Rezoning Application: PD 22-0461

Development Services Department

1.0 APPLICATION SUMMARY

APPLICATION NUMBER:	PD 22-0461	
ZHM HEARING DATE:	November 14, 2022	
BOCC LUM MEETING DATE:	January 10, 2023	Case Reviewer: Michelle Heinrich, AICP

8.0 PROPOSED SITE PLAN (FULL)

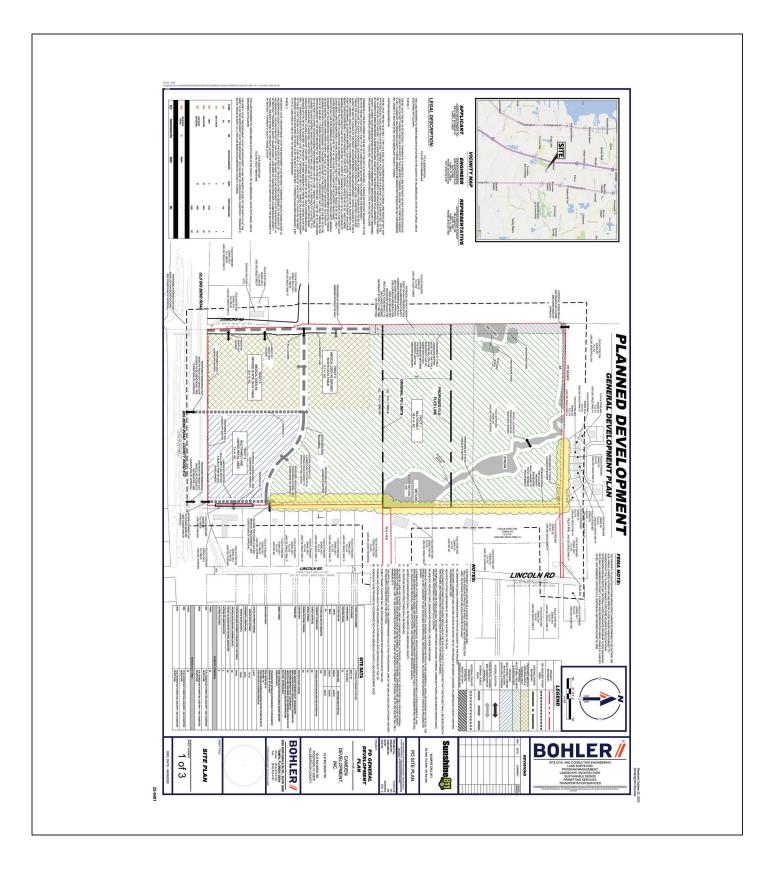
- 6. Site Plan to delineate and label the Hillsborough County parcel located along the eastern boundary of the PD.
- 7. On all sheets, remove the word "Extension" from Simmons Rd.

- 15. On Sheet 1 of 3, modify the graphic depiction of the potential access area bounding box such that its southernmost extent runs to the limits of the southern PD boundary.

8.0 PROPOSED SITE PLAN (FULL)

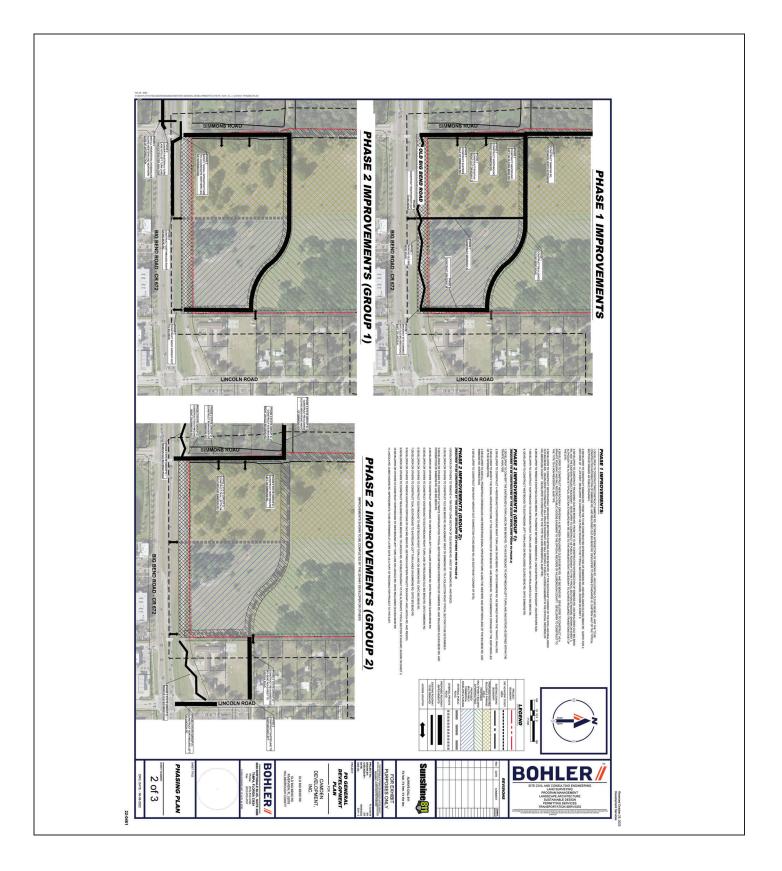
- 9. On Sheet 2 of 3, replace the three (3) references stating "By the 22-0461 Developer" to instead state "By the Developer of the Subject PD".
- 10. For all Typical Sections on Sheet 3 of 3, ensure all individual components are labeled. For example, label the 5-foot wide and 1-foot wide areas as "Grass Strip". On the "Driveway A" and "Driveway B" Typical Sections, ensure that it is labeled as "Type F curb and gutter".

- 12. On Sheet 2 of 3, add to the "Phase 2 Improvements (Group 2)" list a new item stating "Developer or others to construct eastbound to northbound left turn lane on realigned Old Big Bend Rd. onto Lincoln Rd."

- On Sheet 2 of 3, modify note 4 and 5 within the "Phase 1 Improvements" list. These incorrectly state these will be constructed to the Type TS-3 non-residential standard. Replace instances stating "Roadway" with "Driveway" within the first two sentences. Replace the last sentence with a sentence stating "Developer to construct to the Typical Section standard shown on Sheet 3 of 3."

- 14. On Sheet 2 of 3, add to the "Phase 2 Improvements (Group 1)" list a new item stating, "Developer to construct a transit bus bay, shelter and amenities see zoning conditions."

8.0 PROPOSED SITE PLAN (FULL)

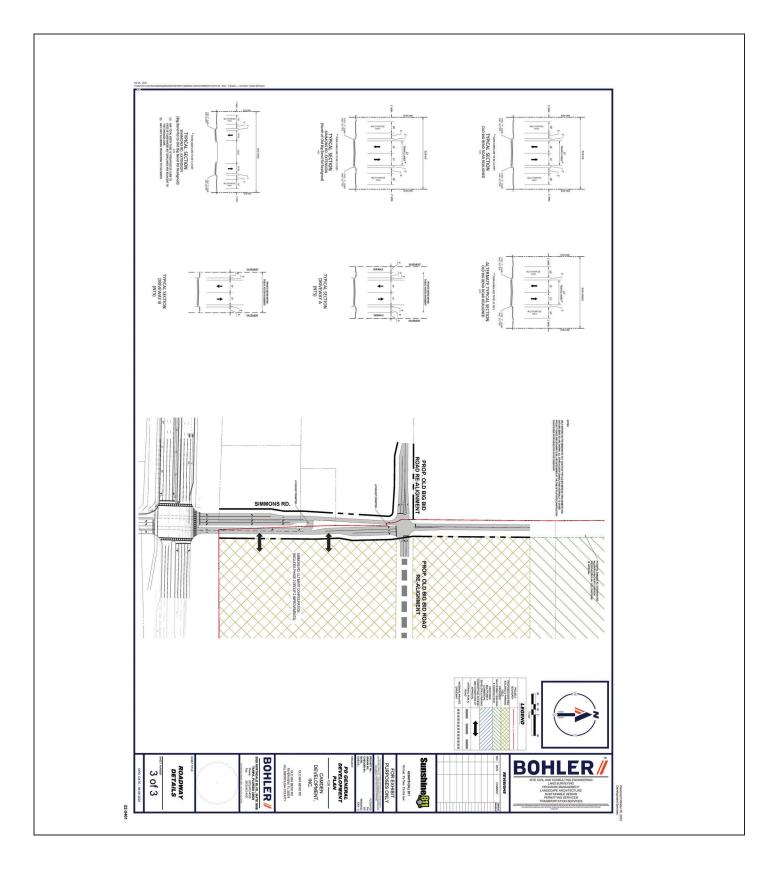
- 8. Modify the "Driveway B" Typical Section on Sheet 3 of 3 to add minimum 5-foot wide sidewalks on both sides of the roadway, separated from the back of curb by 5-foot wide green strips. Add a footnote applying to the sidewalk on the east side of the roadway. Footnote shall state "The sidewalk along east side of road is optional; however, such sidewalk shall be constructed together with any vehicular access constructed within the "Potential Access Area" as shown on Sheet 1 of PD site plan (i.e. the optional access to/across folio 77550.0000)."

- 11. On Sheet 3 of 3, please ensure label stating "Simmons Rd. Ultimate Configuration (Includes Phase 2 Group 2 Improvements)" is prominently shown. It should appear either at the top or bottom of the graphic. Consider placing it above the note near the top left corner of the graphic, with a bold font that is at least as large as the other text in the graphic.

TYPICAL SECTION OLD BIG BEND ROAD REALIGNED

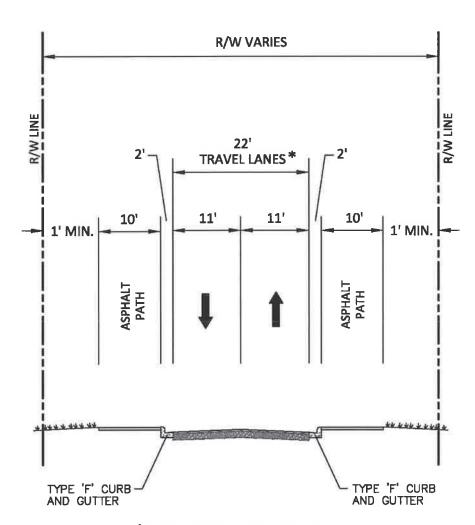
The request is for a Design Exception to TS-4 of the Hillsborough County Transportation Technical Manual for Old Big Bend Road. The segment of Old Big Bend Road is currently a two (2) lane roadway and the developer proposes to realign the roadway, as shown in Figure 1. The following exceptions are requested to accommodate the proposed project.

The developer proposes two alternative sections. The first is from Simmons Loop Extension east through the project to the transitions to the drainage canal. This section is shown in Figure 2. Figure 3 illustrates the proposed section where the roadway crosses the drainage canal on the eastern portion of the property.
